# Triennial Review, VRR Curve Shape Issue: Problem Investigation and Recommended Further Analysis (Part I)

**James F. Wilson**

PJM Capacity Senior Task Force

July 11, 2014

# Load Forecasts Can Change (and are more likely to go down than up)

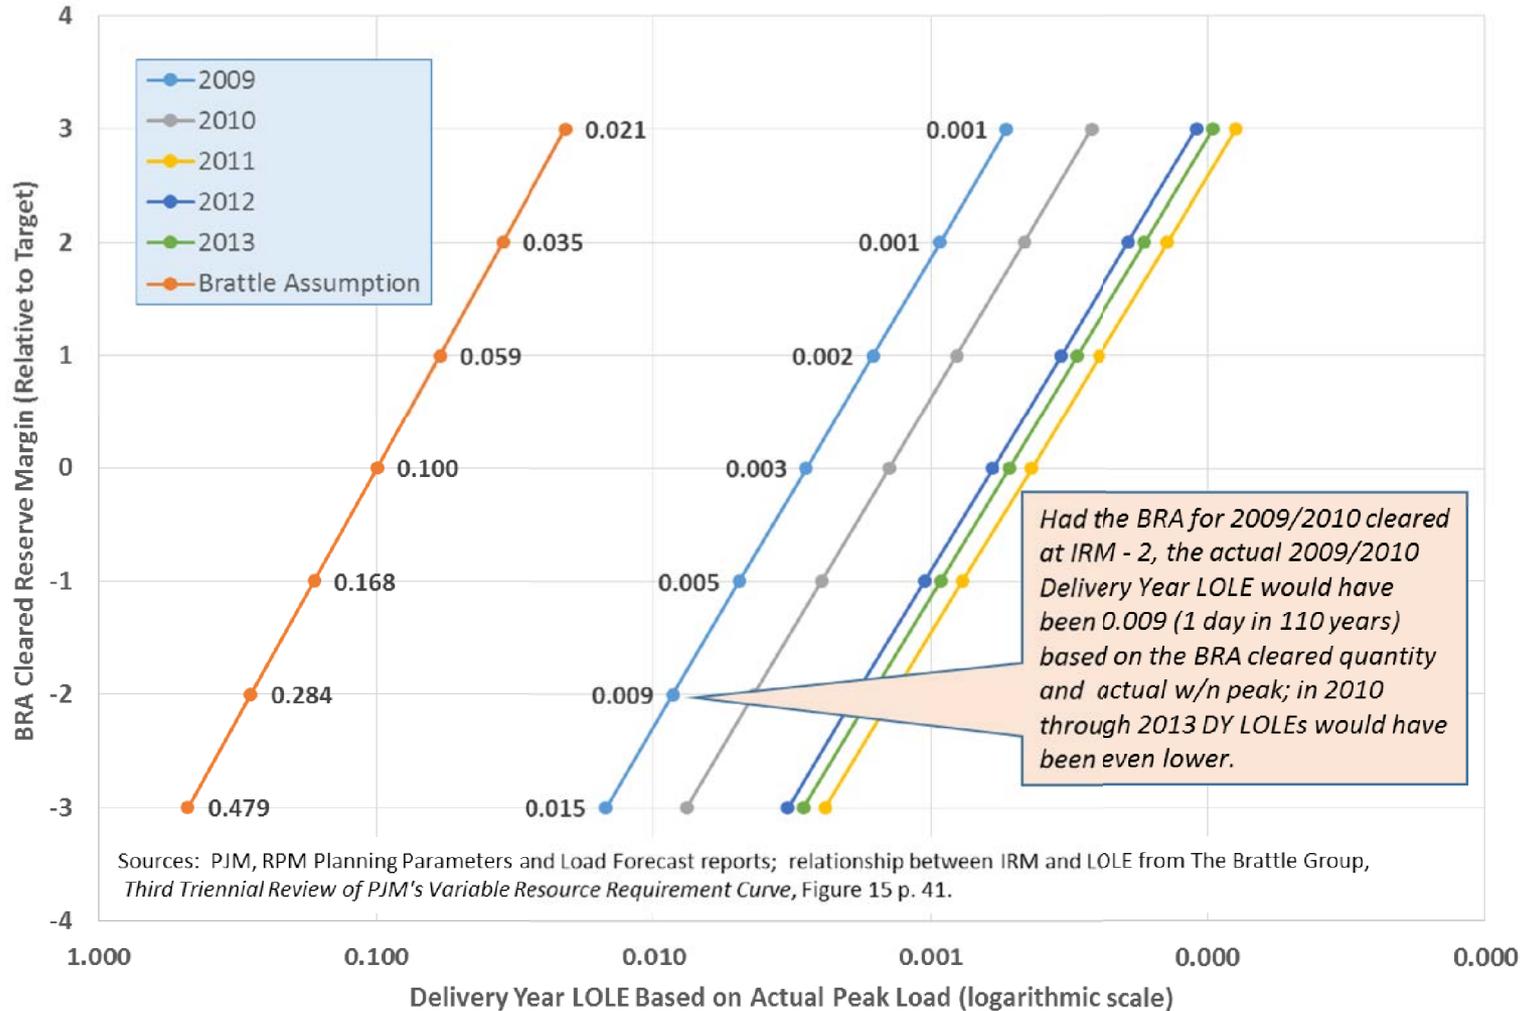
- Recent history – consistently very large reductions
- PJM’s position – going forward, reductions in capacity needs after the BRA remain more likely than increases for at least two reasons:
  1. Conservative planning parameters: “Over the three years leading to a Delivery Year, the net effect of all changes in planning parameter determinations seems more likely to move in a direction of lesser need for resource procurement than greater need for resource procurement” *PJM in ER14-1461, 3/10/2014, p. 8.*
  2. Optimistic economic forecasts used in load forecast: “Economic growth forecasts have actually been overly optimistic. This has been driving the forecast on load. It’s been a systematic bias that has gone on for so long. I just don’t see that changing” *Paul Sotkiewicz @ UBS, 6/13/13, p. 16.*

# Additional Modeling and Analysis Would Be Required to Estimate DY RM0, LOLE Outcomes *(not recommended!)*

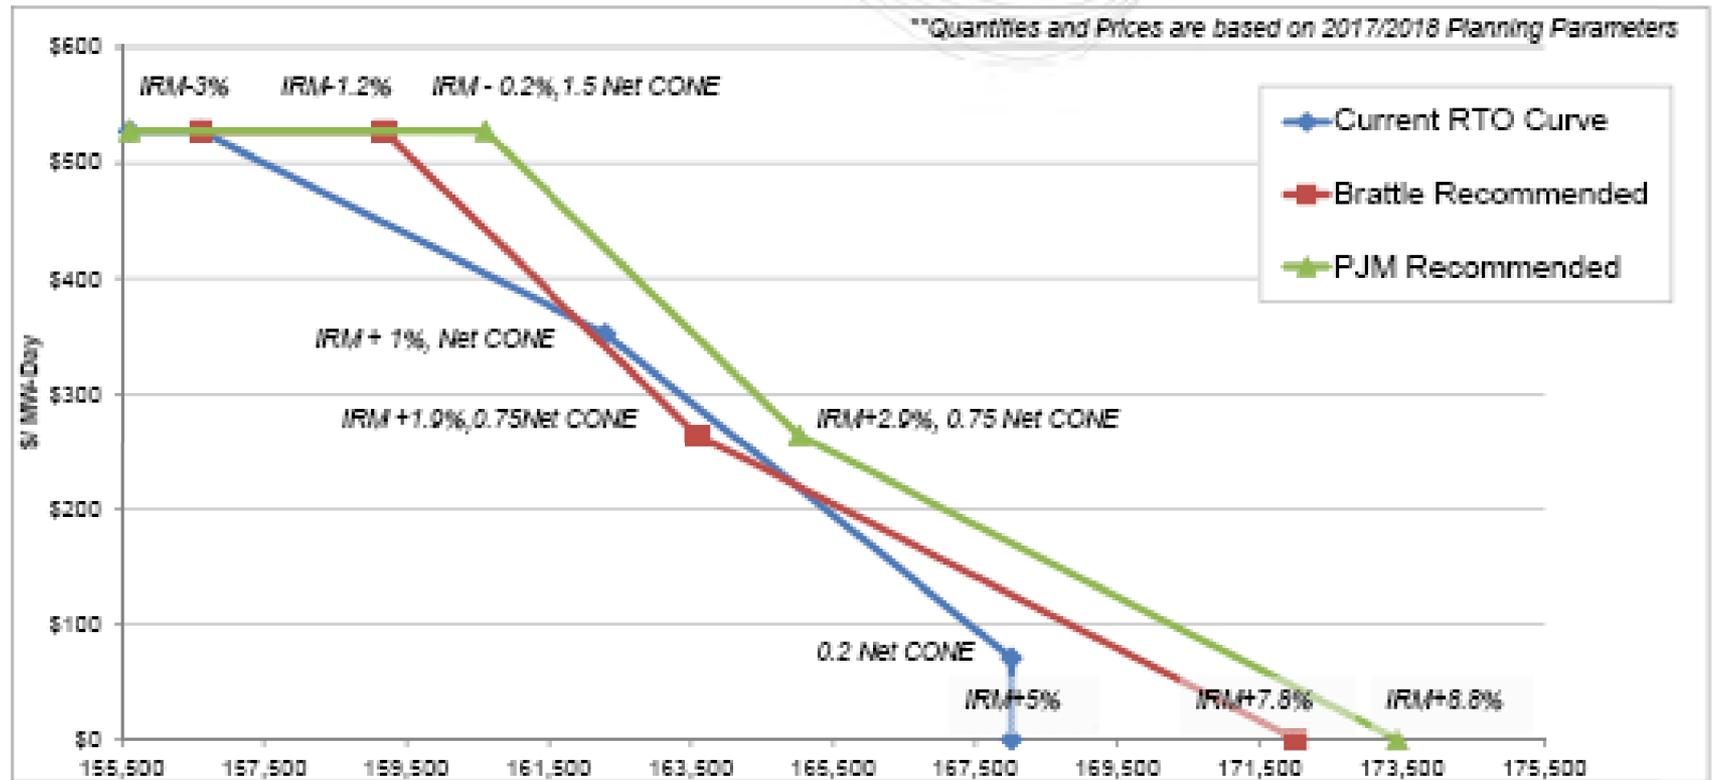
Due to load forecast adjustment and capacity purchases, RM0 will often be much improved over RM3 whenever RM3 is low.

The Brattle work does not do this modeling; it reports LOLE based on simply assuming  $RM0 = RM3$ .

*The fact that the current rules do NOT call for PJM to attempt to acquire additional capacity in IAs if clearing below target in the BRA indicates stakeholders are comfortable with such outcomes occurring at times.*

- Model changes to load forecast; biased in downward direction
- Model changes in the transmission system and import capacity
- Model resources available after the BRA, both uncleared in BRA and short lead time
- Model PJM capacity acquisitions (in IAs, also backstop rules) and consider changes to those rules
